APPLICATION NO.	FILING DATE	FIRST NAMED INVENTOR	ATTORNEY DOCKET NO.	CONFIRMATION NO.
09/994,741	11/28/2001	Thomas Blattner	A03195	8342

Office Action Summary

DETAILED ACTION

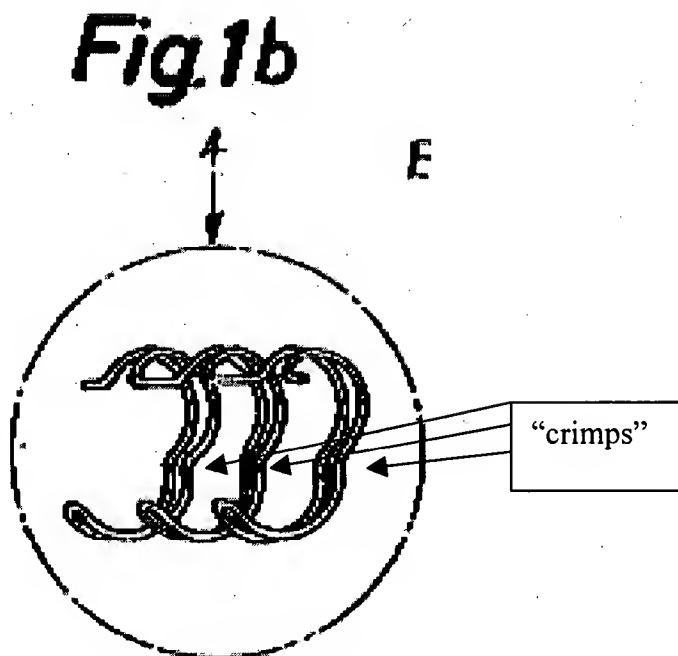
Re claim 3, it is noted that at least the section so indicated in the reproduction of Figure 1b below can be considered to be a “crimp” that is “formed” in a loop of the looped binding element.

Re claim 4, it is noted that there are a "series" of such crimps as shown in the above reproduction of Figure 1b.
